IN THE UNITED STATES PATENT AND TRADEMARK OFFICE

In re Continuation Reissue Application)
of Serial No.: 08/341,585)
Inventor: Michel Gondouin) Group Art Unit
Serial No.: Unassigned) in Prior Application: 3625
Filed: September 4, 2001) Examiner in
For: DOWNHOLE EQUIPMENT, TOOLS) Prior Application: H. Dang
AND ASSEMBLY PROCEDURES)
FOR THE DRILLING, TIE-IN AND)
COMPLETION OF VERTICAL)
CASED OIL WELLS CONNECTED)
TO LINER-EQUIPPED MULTIPLE)
DRAINHOLES)

PRELIMINARY AMENDMENT

REQUEST FOR APPROVAL OF DRAWING CHANGES

FIG. 3

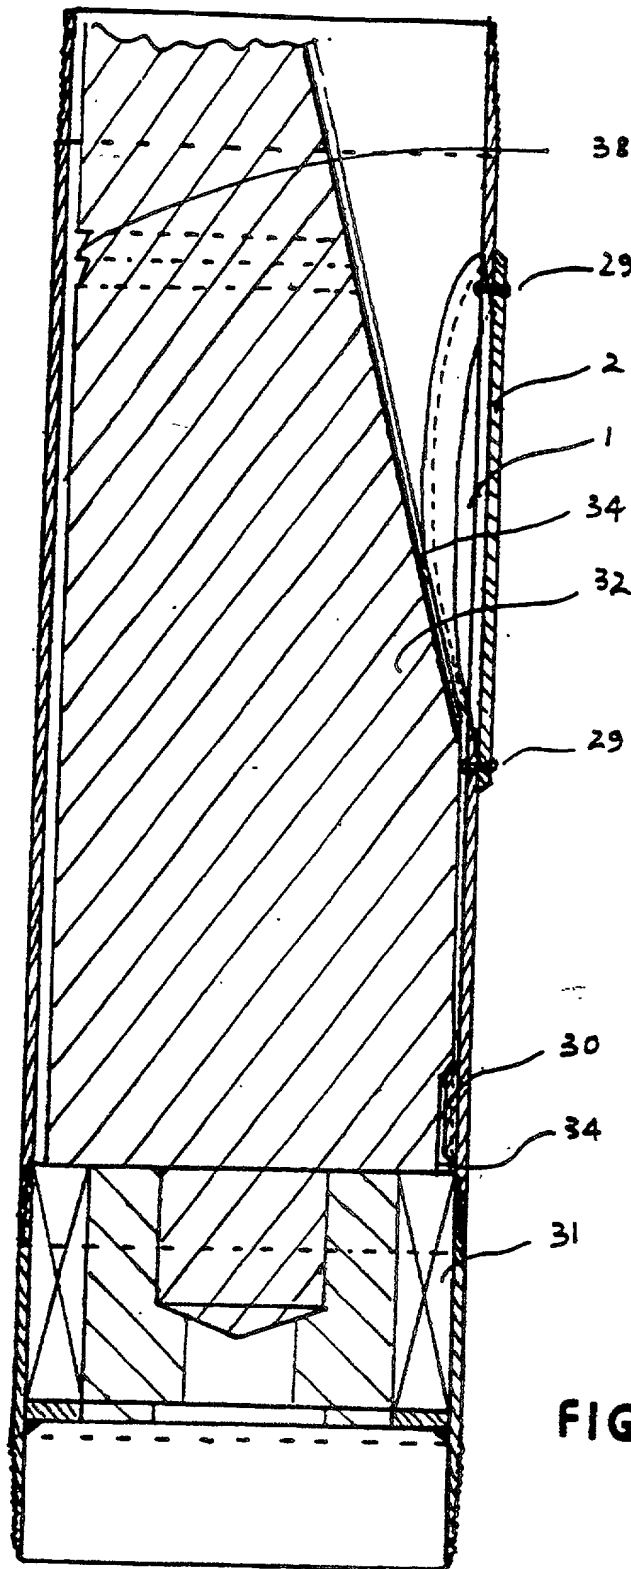
Pursuant to the condition of the Decision of this Office dated October 8, 1999, granting Applicant's Petition for the original filing date, please cancel Figs. 3 and 6 of the drawings from this application, as shown in Figs 3 and 6 in the attached Request for Approval of Drawing Changes in which the figures are enclosed within brackets (in red on the attached drawing) and identified as "CANCELED" (again in red). By these changes to Figs. 3 and 6, Application does not intend to cancel Figs. 3a, 3b, 3c, 6a, or 6b.

Applicant also requests that Figs. 3 and 6 be canceled in total according to reissue practice. As M.P.E.P. § 1413 requires, the original Figs. 3 and 6 are enclosed within brackets (in red on the attached drawings) and identified as "CANCELED" (again in red).

FIG. 4

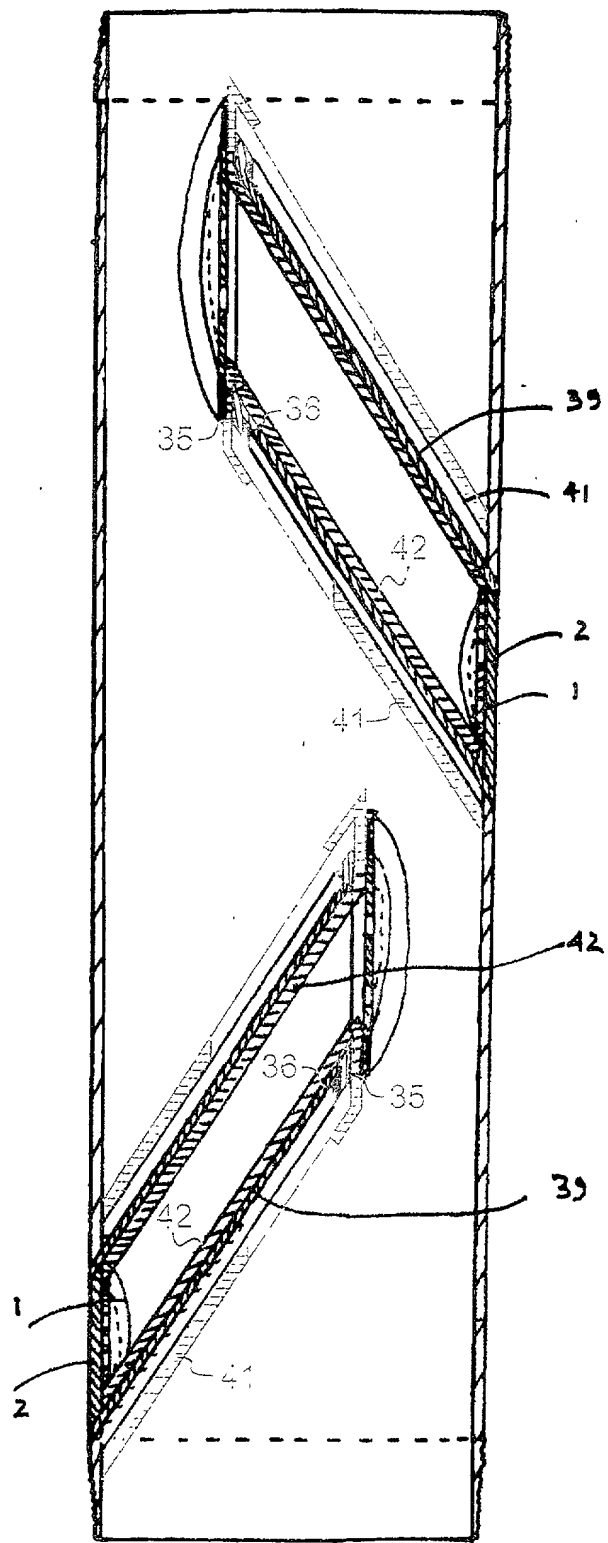
Also, please amend Figs. 4 and 10 as indicated in the attached Request for Approval of Drawing Changes.

Applicant is also presenting proposed amendments to Figs. 4 and 10. These proposed amendments were discussed during an interview with the Examiner in the parent application and were accepted by the Examiner in that case. Applicant is formally submitting the proposed drawing changes in the accompanying Request for Approval of Drawing Changes. These drawings are the same as the drawings considered and accepted by the Examiner in the parent application. Applicant submits that these proposed drawings fully comply with the Office's Rules and the MPEP.

Pursuant to 37 C.F.R. § 1.121, Applicant requests approval of the attached drawing changes. Applicant has submitted these changes by way of a new sheet of drawings with Figs. 4 and 10 identified as amended. 37 C.F.R. § 1.121(b)(3)(i). Moreover, these drawings constitute a sketch in permanent ink and the proposed changes are shown in red. 37 C.F.R. § 1.121(b)(3)(ii).
